Construction of Landfill Cell 5 at Central Landfill Facility Worcester County, Maryland

19 July 2017
EA Project No. 1060932

RE: Addendum No. 1
Worcester County Department of Public Works
Central Landfill Facility Site – Landfill Cell 5

ELECTRICAL SITE PLAN III

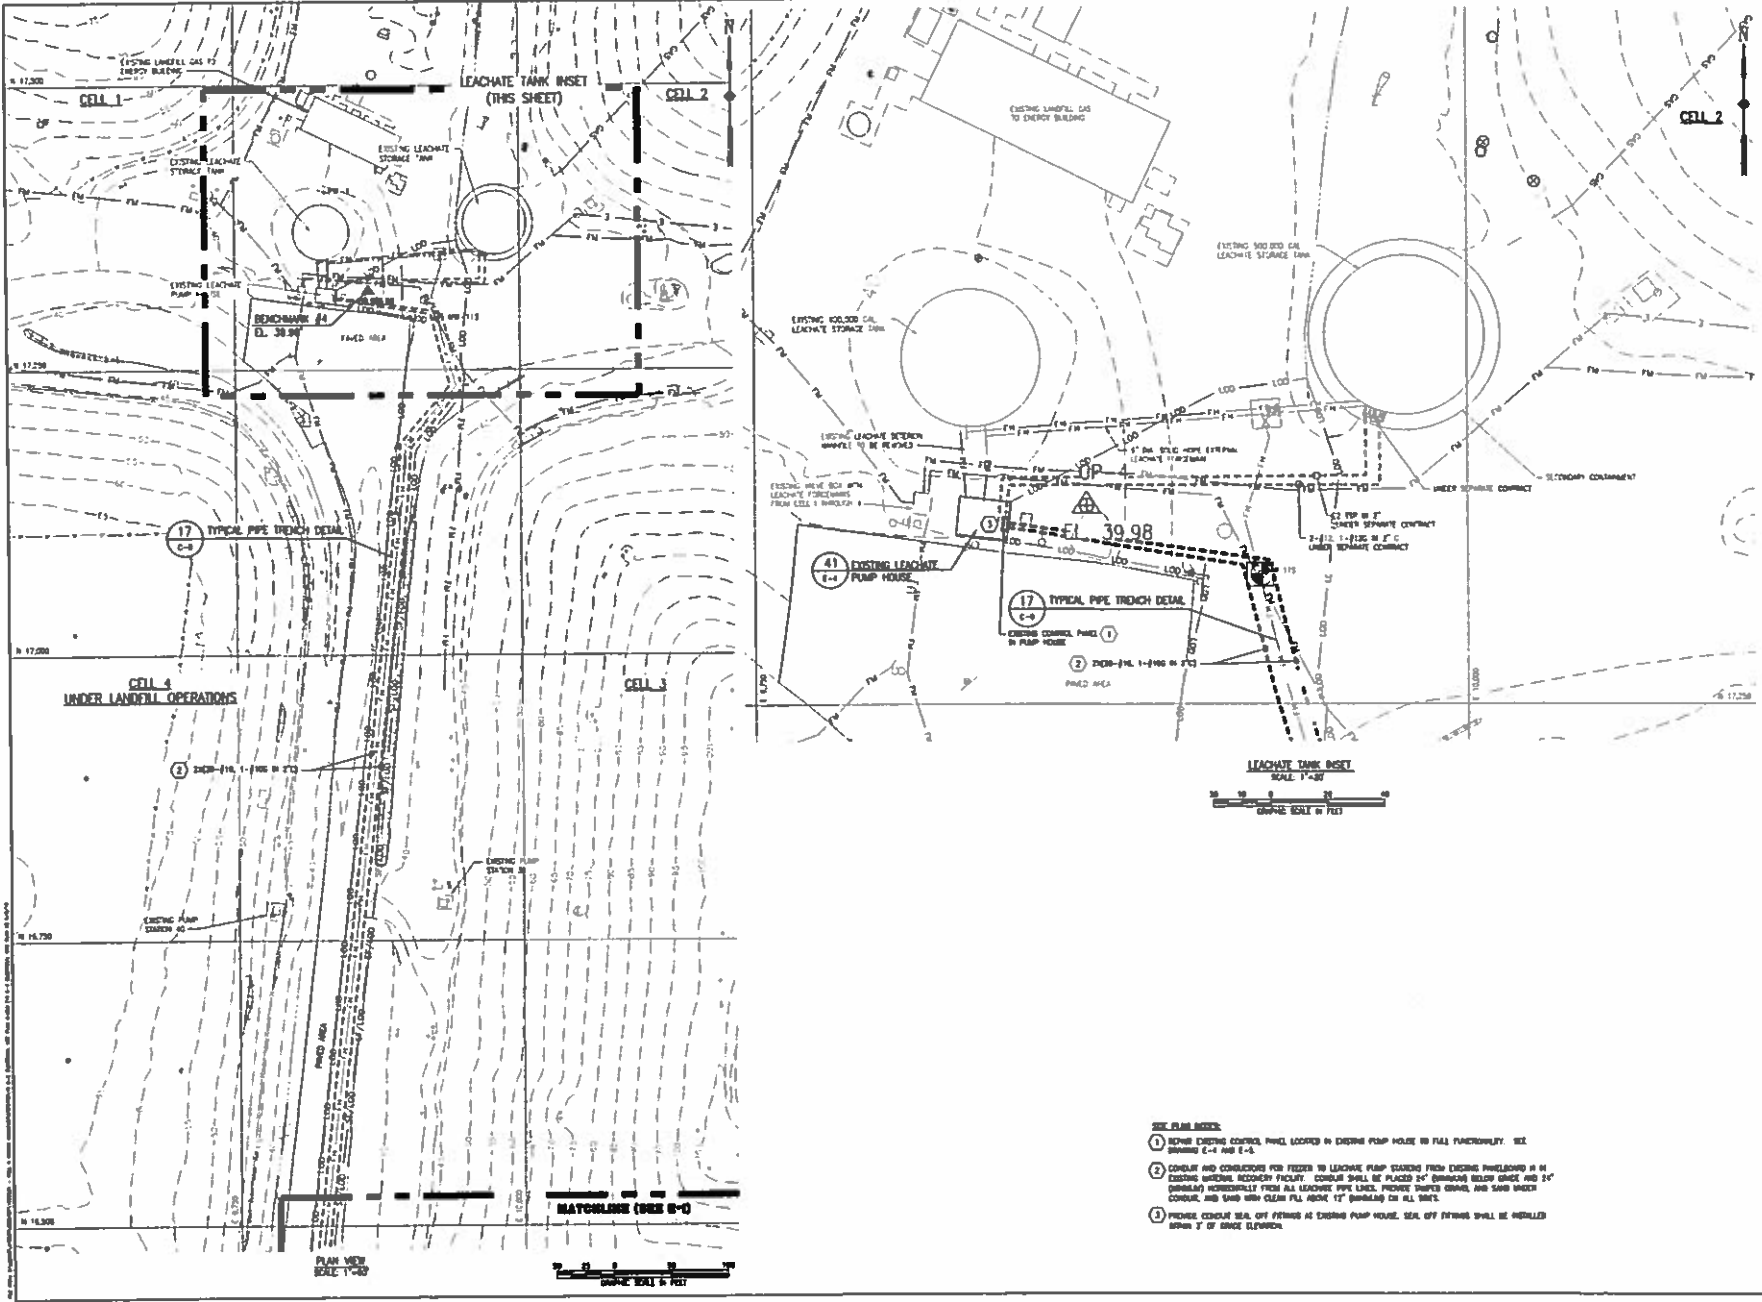
1. ADD: Drawing E-3.

- SEE PLAN NOTES:**
- 1) REPAIR EXISTING CONTROL PANEL LOCATED IN EXISTING PUMP HOUSE TO FULL FUNCTIONALITY. SEE SHEETS E-4 AND E-5.
 - 2) CONDUIT AND CONDUITORS FOR FEEDER TO LEACHATE PUMP STARTING FROM EXISTING ENVELOPEDS IN EXISTING WASTEWATER RECOVERY FACILITY. CONDUIT SHALL BE PLACED 24" (MINIMUM) BELOW GRADE AND 24" (MINIMUM) HORIZONTALLY FROM ALL LEACHATE PIPE LINES, FIBER OPTIC CABLES, AND SAND UNDER CONDUIT, AND SAND WITH CLEAN FILL ABOVE 12" (MINIMUM) TO ALL FEEDS.
 - 3) PROVIDE CONDUIT SEAL OFF FITTINGS AT EXISTING PUMP HOUSE. SEAL OFF FITTINGS SHALL BE INSTALLED UPON 1" OF BRASS ELEVATION.
